**STAFF REPORT TO THE PLANNING COMMISSION**

**SUBJECT:** Leung Property Project Preliminary Development Plan (PDP23-02)

Re: **Engineering review of the Leung Property Preliminary Development plan application for General Plan Amendment.**

1. NEIGHBORHOOD PARK

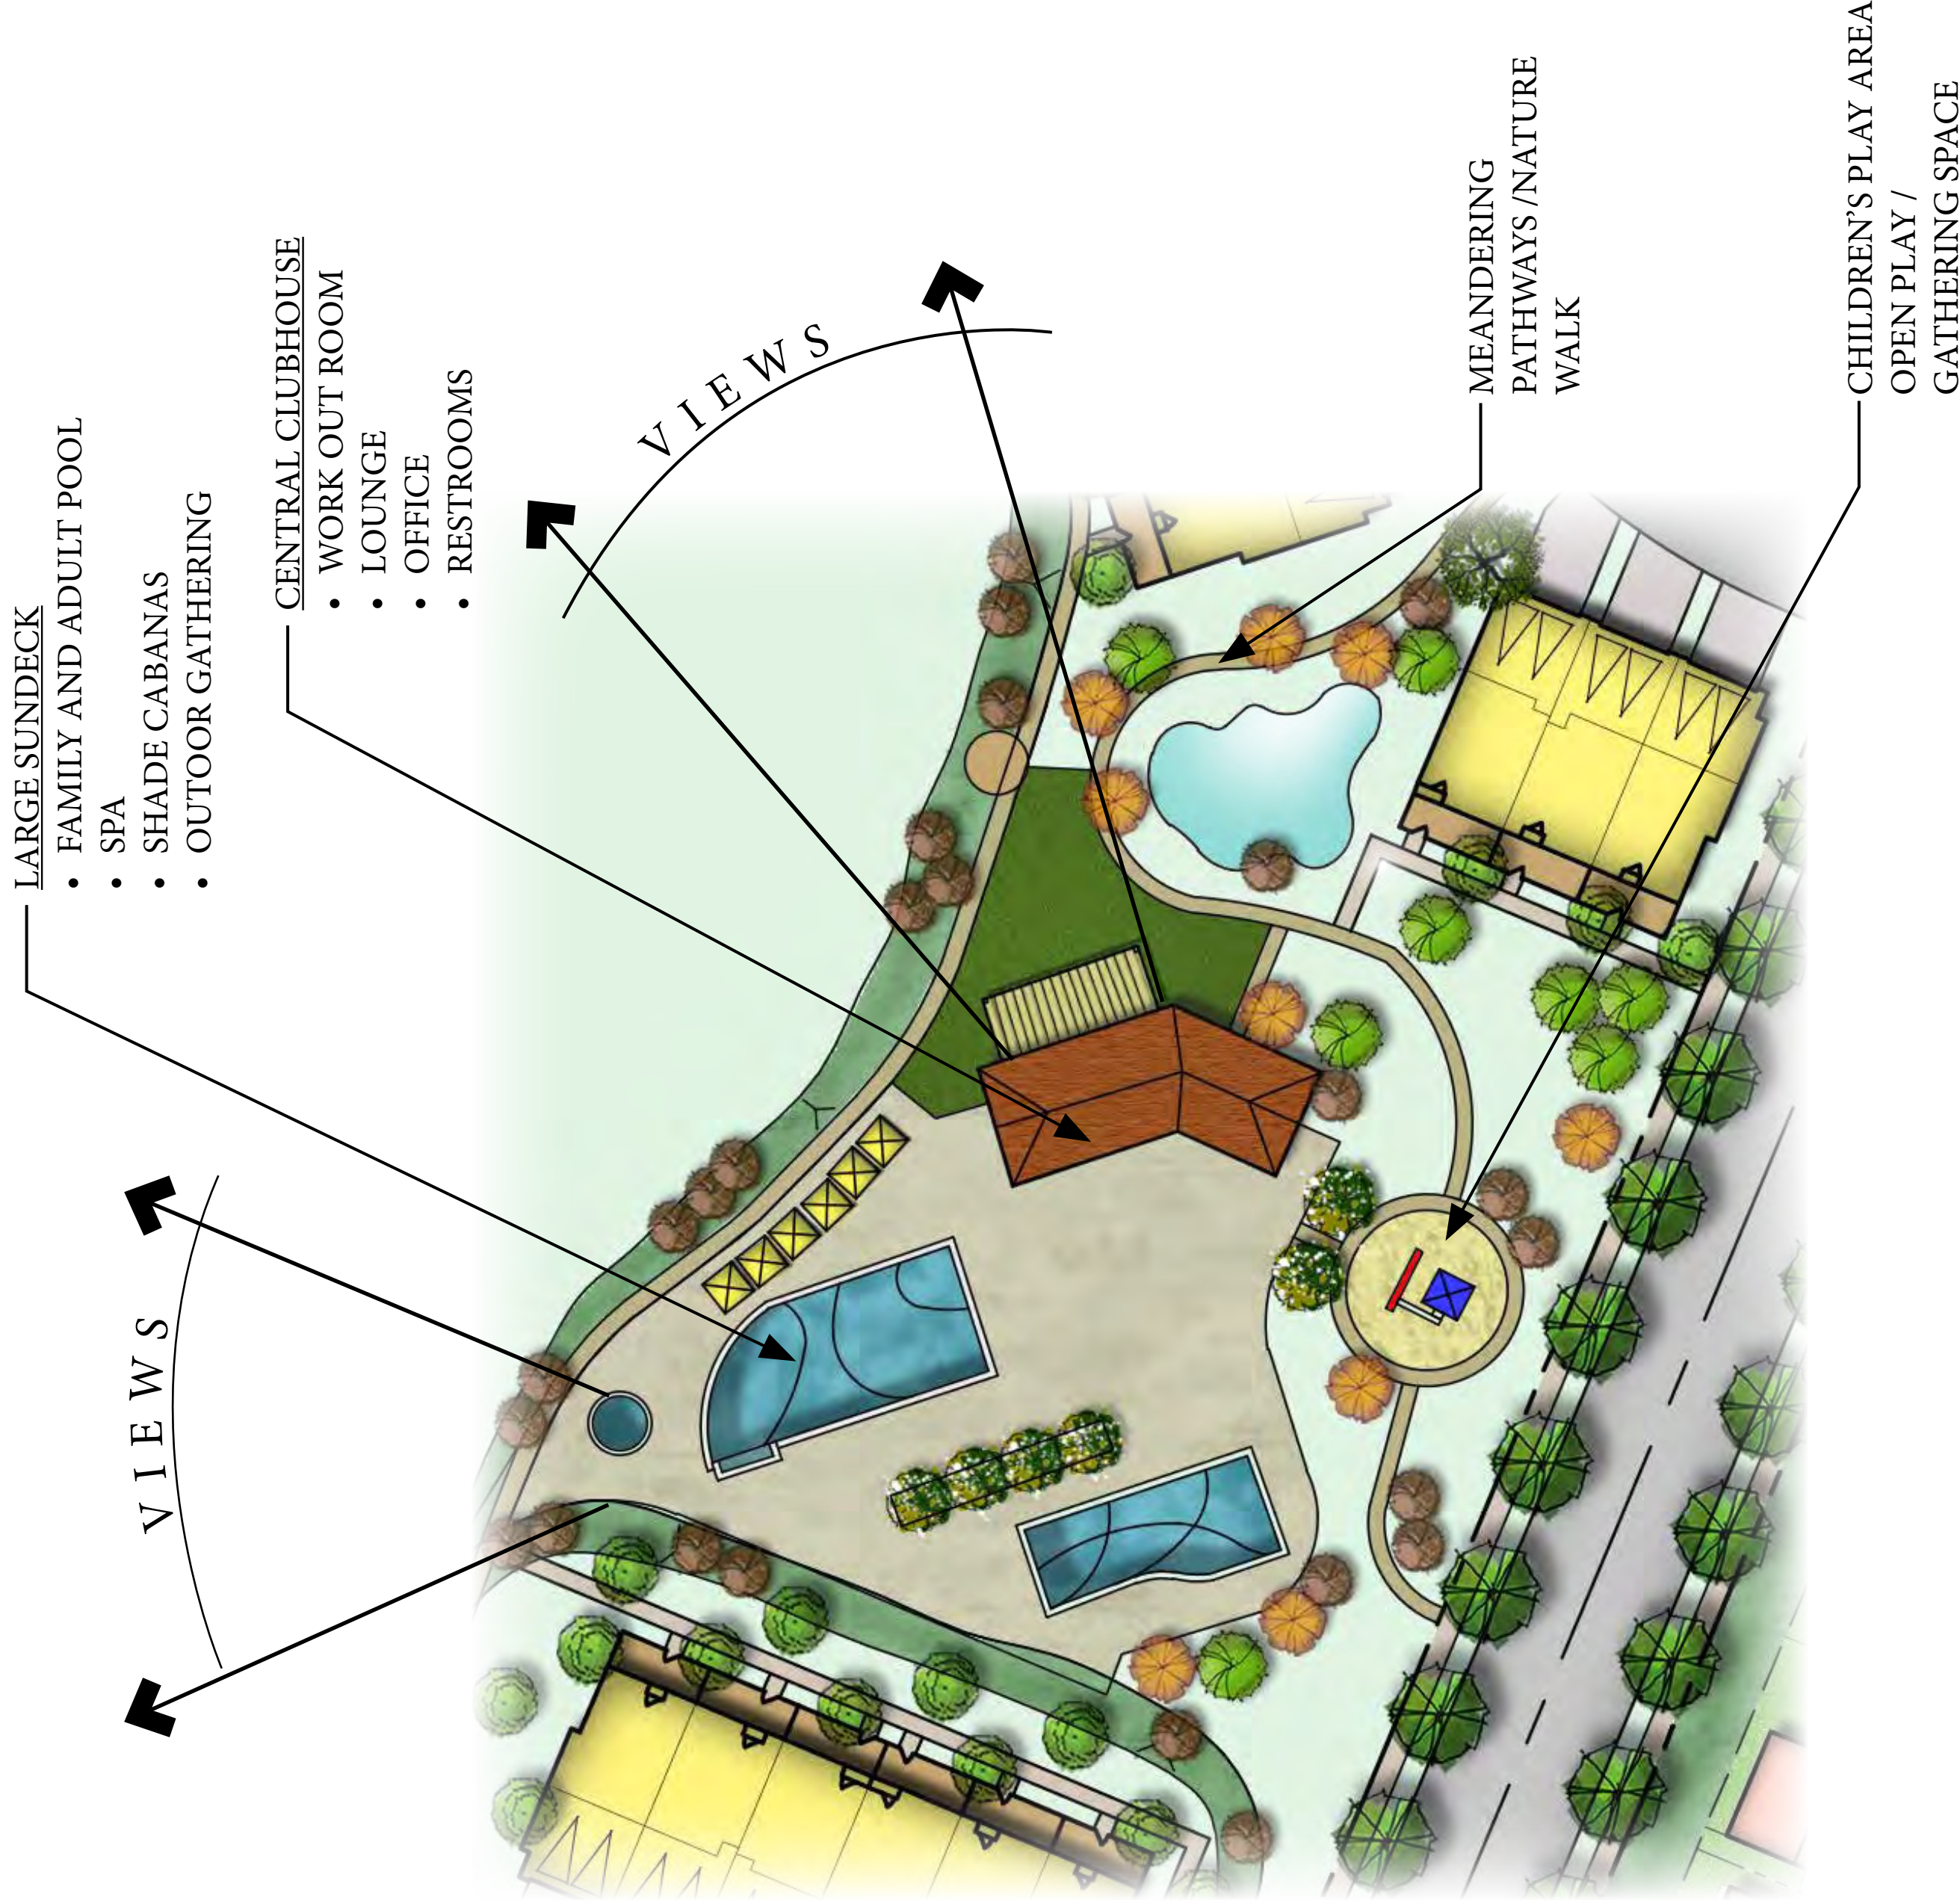
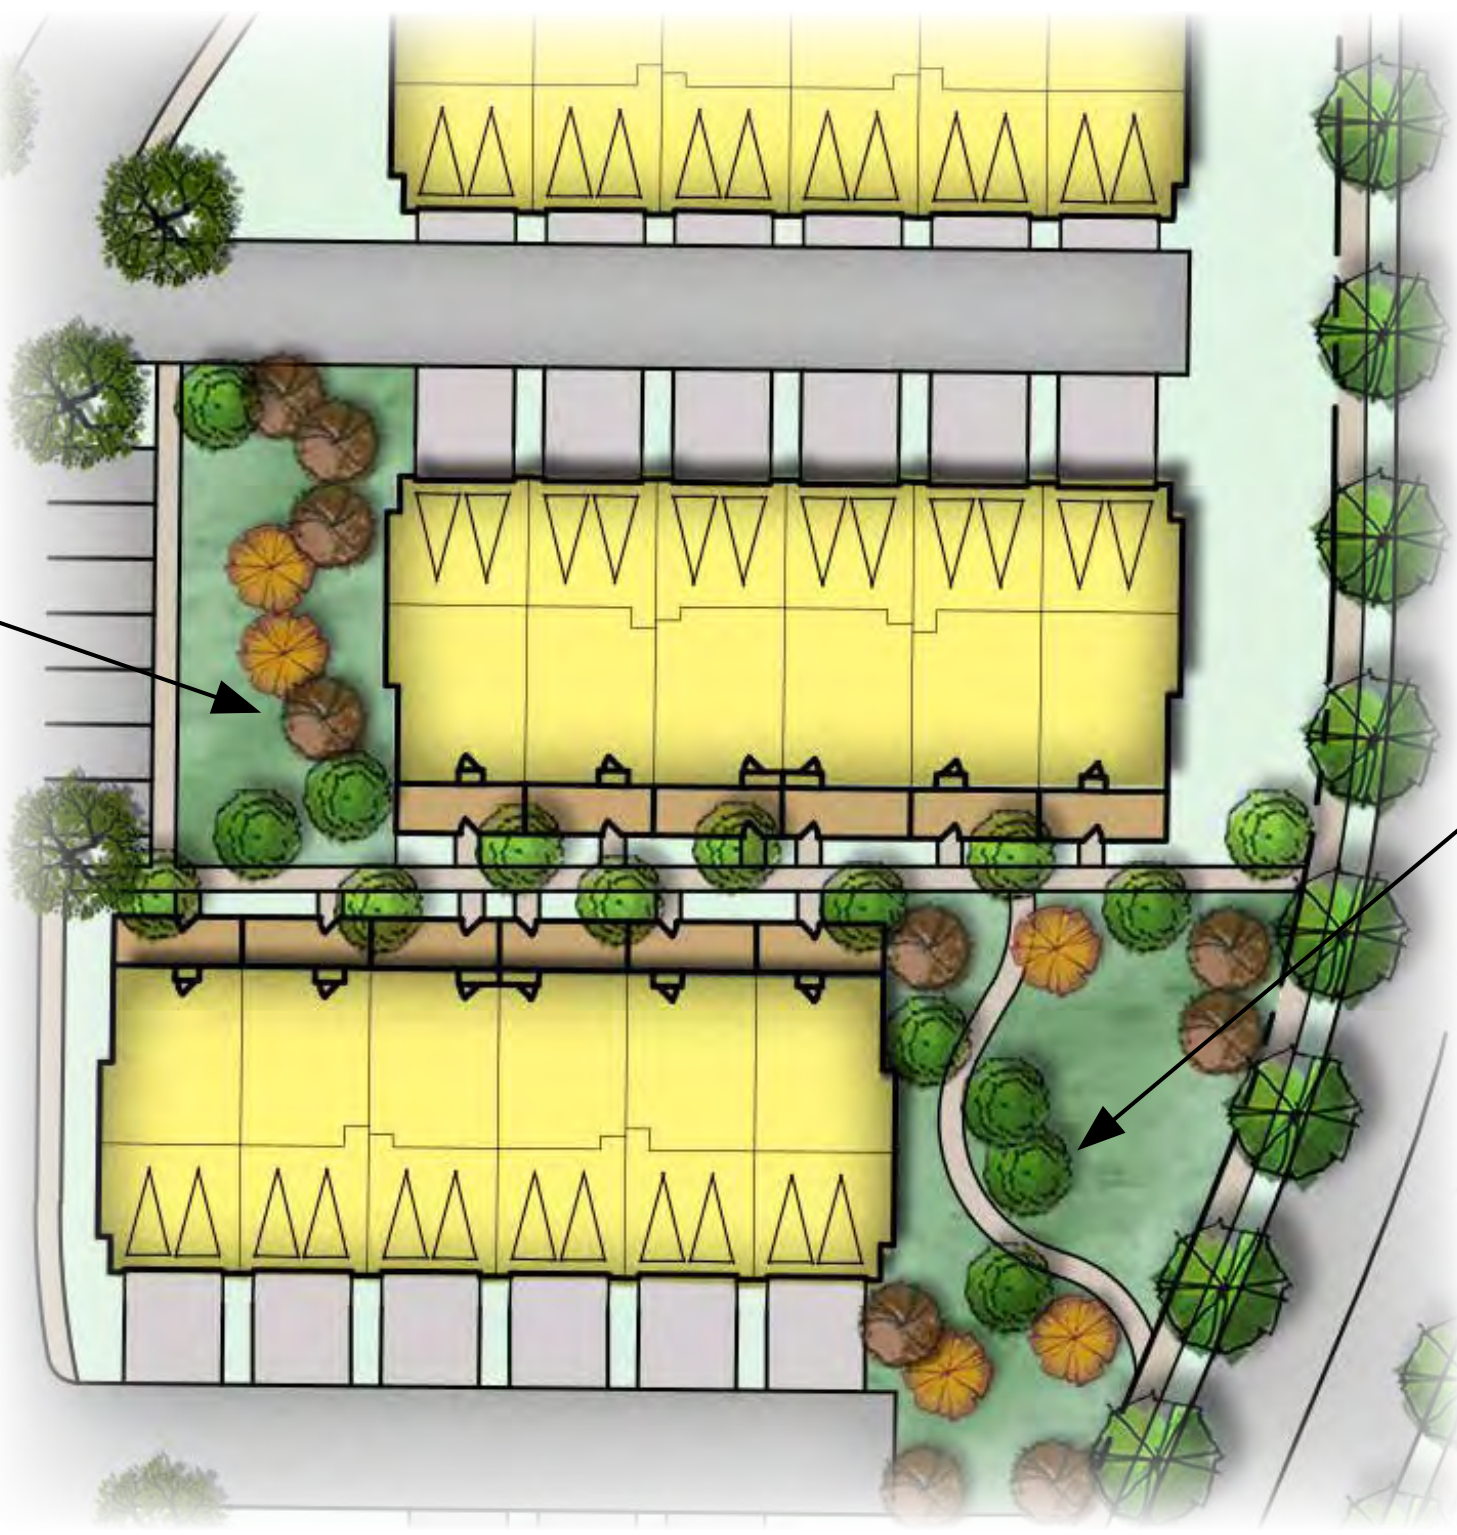
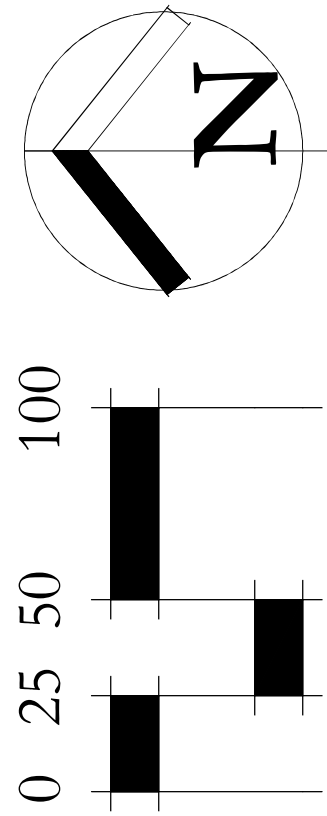
- Neighborhood Park
  - a. Provide dimensions of the meandering pathway.
  - b. Need a children’s play area.
  - c. Need a full-size asphalt basketball court.
  - d. Need to show how big the play area is. Is there enough room to play soccer, baseball, etc. within the designated play areas.
  - e. Add any other amenities in the park for the benefit of the residents.
- Central Recreation Center
  - a. There is no parking available to park at this recreation center. Provide needed parking for residents and guests and employees of the sales office and center.

- b. Childrens play area is too small. Provide larger Childrens play area for the number of residents that could use this service.
  - c. Provide barrique pits and picnic tables to hold birthday parties in the park area.
  - d. Provide a lot more benches for parents to sit to watch their kids swim by the pool and park.
  - e. Provide a security gate and fence around the pool area.
- Pocket Park
  - a. Provide 3 point turn around at the end of each dead end parking drive isle.
  - b. Provide the approximate square footage of passive open space play area.
  - c. Provide dimensions of width of all walkways within the development.
